California Public Utilities Commission

Attn: Power the South Bay Project (A.24-05-014)

Re: Comments on the Draft Environmental Impact Report (DEIR) for the LS Power Grid California, Power the South Bay Project (SCC # 2023071095)

**Potential waters of the U.S./State appear to have been missed within Staging Area 3:**

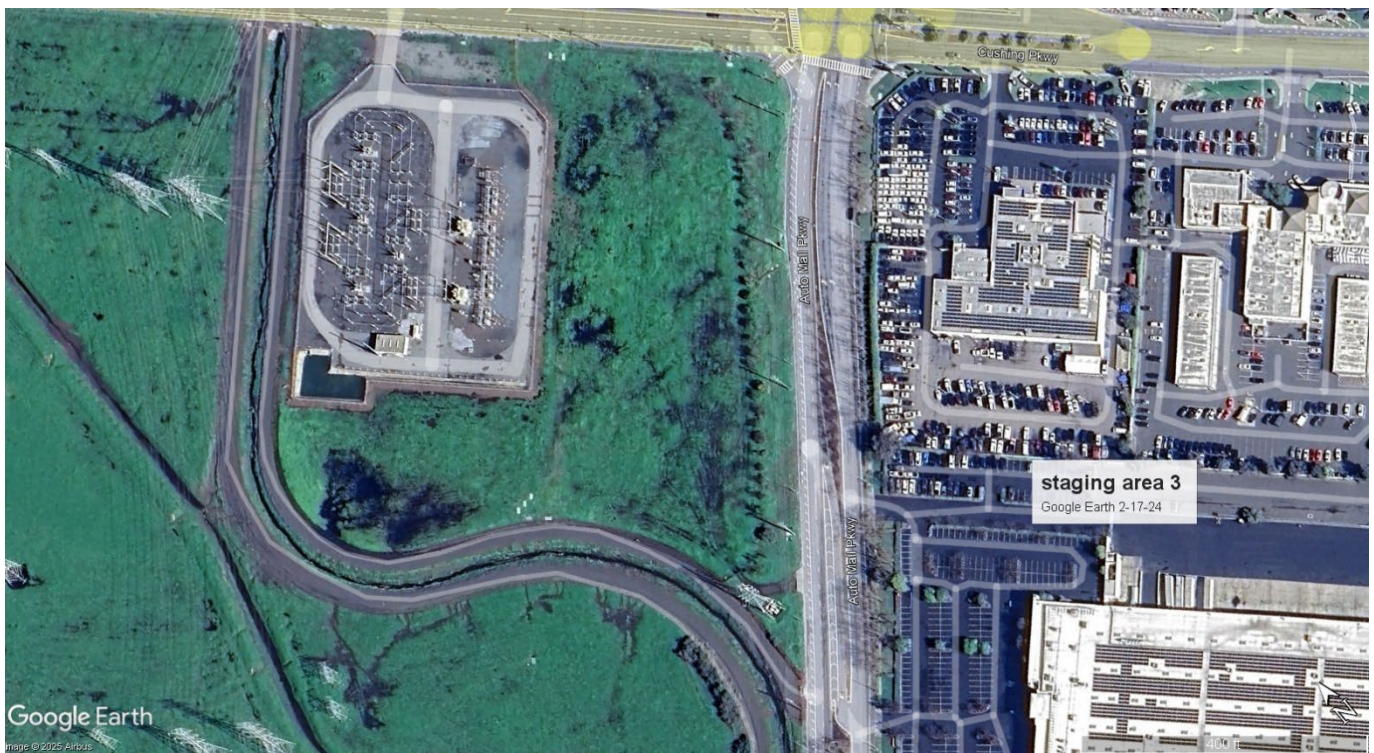
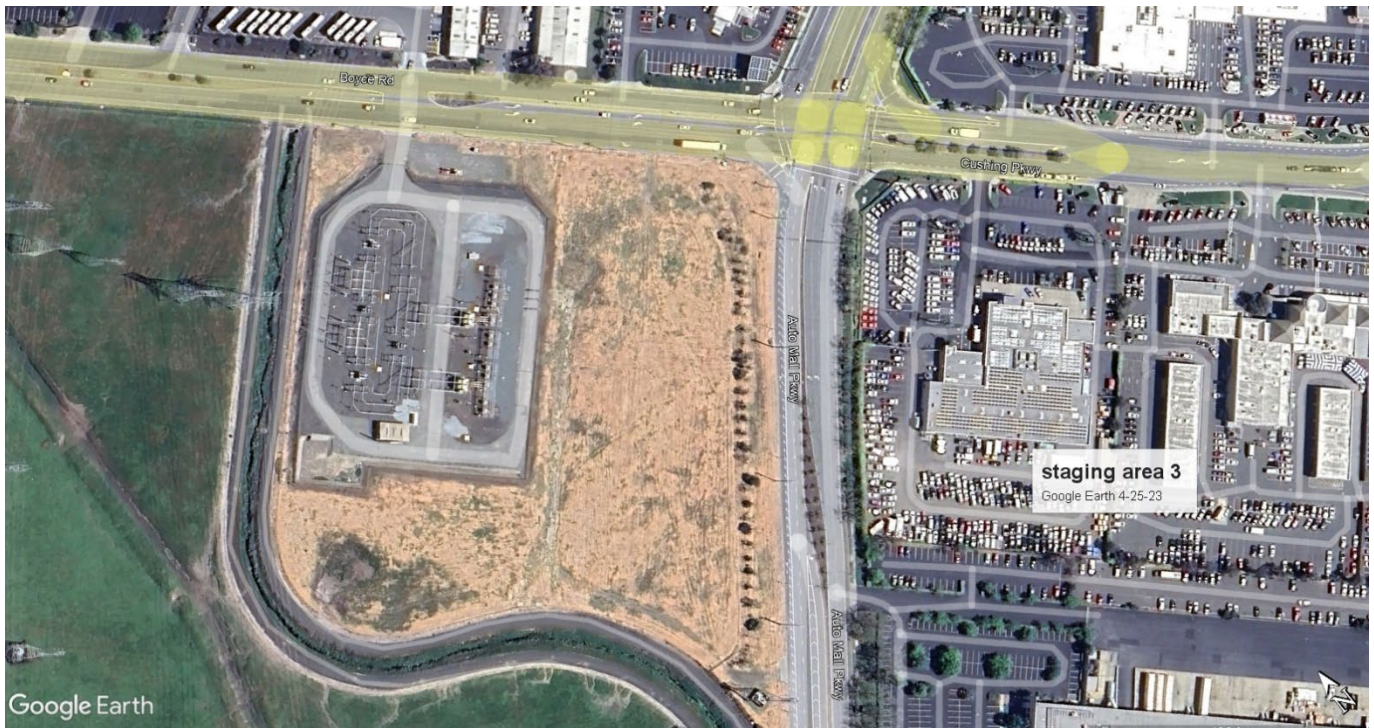
Figure 3.4-1A depicts two habitat types within Staging Area 3 – “disturbed” and “annual grassland.” Our review of Google Earth aerial images suggest that wetlands habitat that has persisted in the same location since 2006 have not been mapped.

The area of interest is outlined in red in the Google Earth image from March 13, 2006 and appears in aerial images from April of 2023 and February of 2024.

We urge that the vegetation community for this staging area be reverified. Additionally, Staging Area 12 should be reviewed for potential waters of the U.S./State.
